SUBJECT: Transmittal of Revised Responses to AP1000 DSER Open Items

**AP1000 Design Certification Review
Draft Safety Evaluation Report Open Item Non-Proprietary Responses**

DSER Open Item Number: 15.3-1 Response Revision 4

Figure 1: MAAP4 Containment Temperature for Sequence 3BE-1

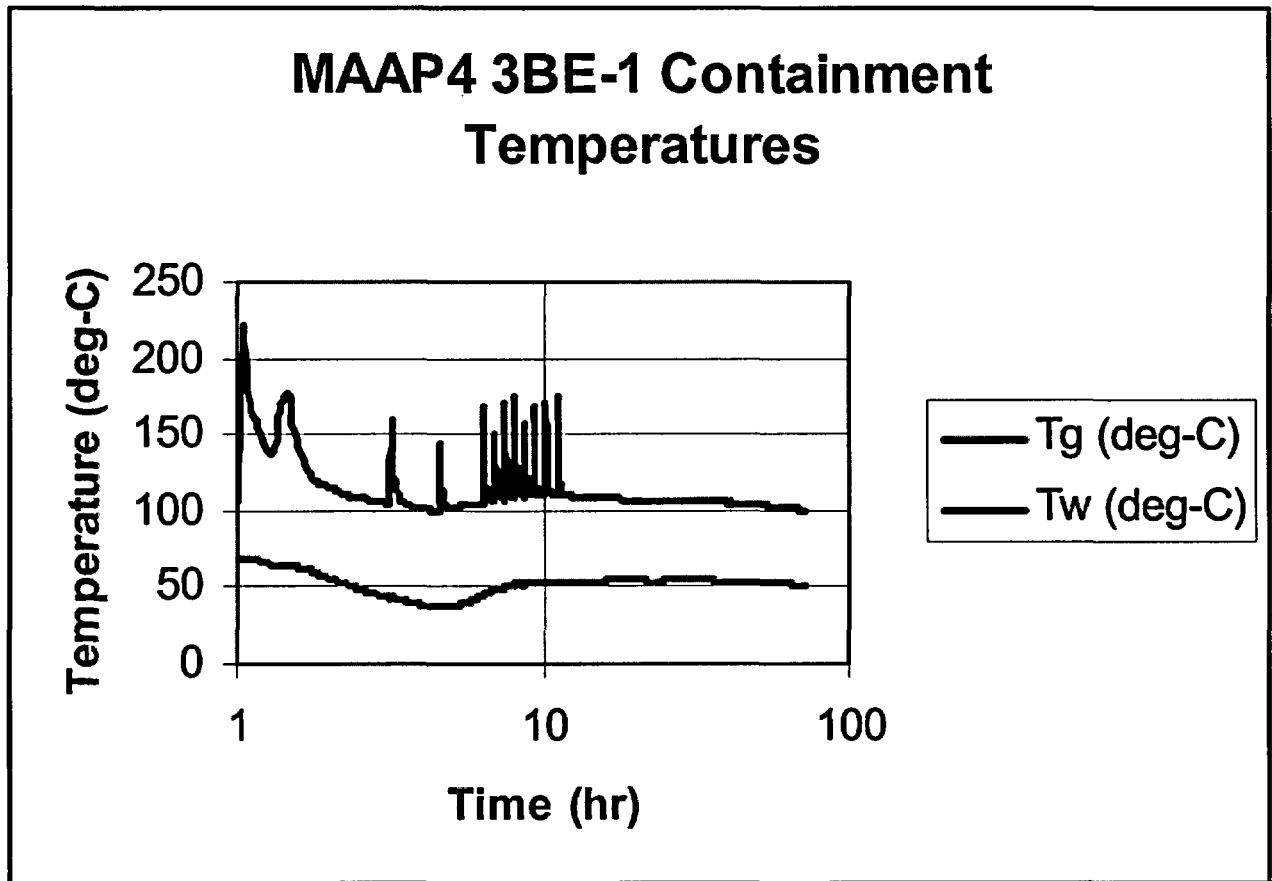
- a) Provide additional justification for aerosol removal by thermophoresis. In particular, address how the heat transfer rate from the air to the containment wall is calculated and applied in the determination of aerosol removal by thermophoresis.
- b) The particle density fraction (0.8) and void content (water) used by Westinghouse are not sufficiently conservative; NRC would agree with particle density fraction of 0.6 and void content of air.

Only convection heat transfer should be used in determining the lambda due to thermophoresis.

The convective heat transfer to the containment shell was determined from the MAAP4 simulation of sequence 3BE-01. The containment gas temperature and the film temperature on the wall are shown in Figure 1 for this sequence. Figure 2 shows the temperature difference between the gas and the film which is the driving mechanism for heat transfer. Figure 3 shows the MAAP4 calculated convective heat transfer to the film on the containment inner surface.

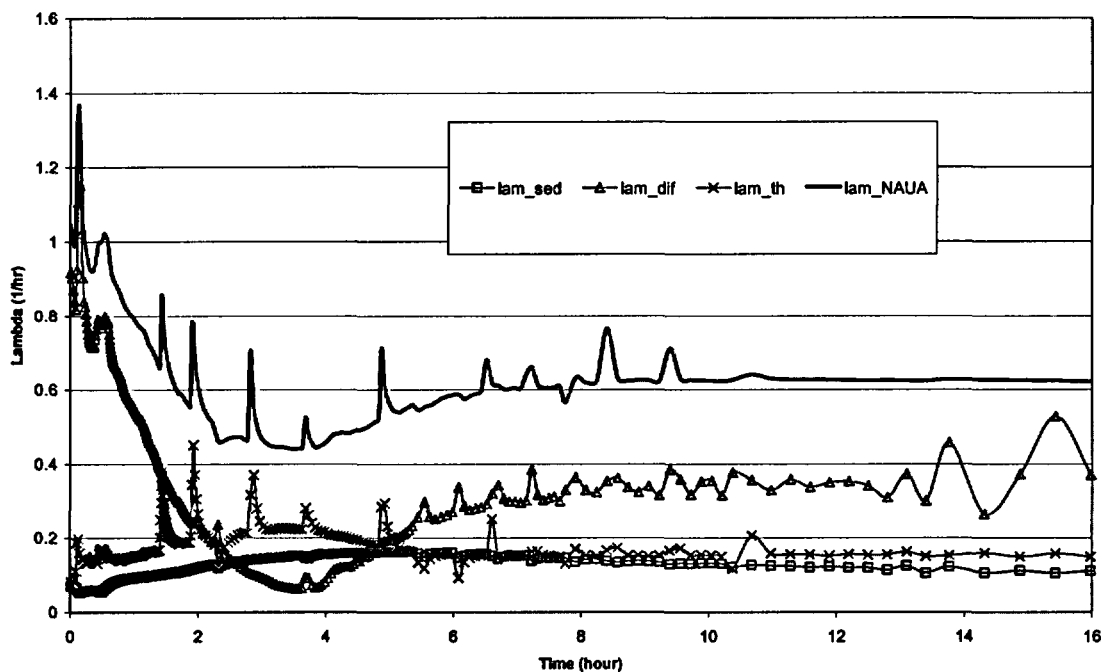
Explain the long term trend of the overall lambda for AP1000 as compared to that for AP600.

The overall aerosol removal coefficients (λ) calculated by STARNAUA are shown in the figure below. These removal coefficients are used in the LOCA dose analysis to determine the offsite and control room doses.

It is noted that the AP1000 overall lambda decreases only slightly after about 7 hours out to 24 hours. For AP600 the overall lambda decreased about 10% over this time period. This difference is assessed as follows.

Lambda Breakdowns for the Case in Which Gap Release Starts 3300 Seconds

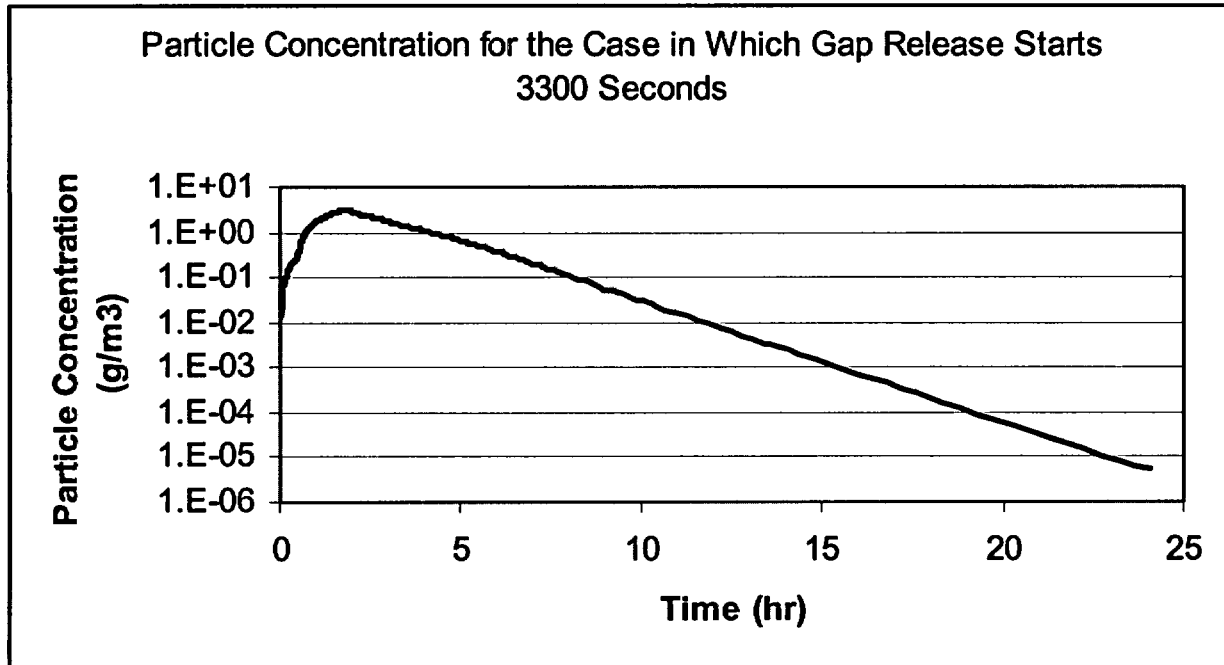
Provide a breakdown of contributions to aerosol removal as a function of time, and provide the total aerosol concentration as a function of time.

The following two figures provide STARNAUA results for lambda elements and for aerosol particle concentration in containment atmosphere.
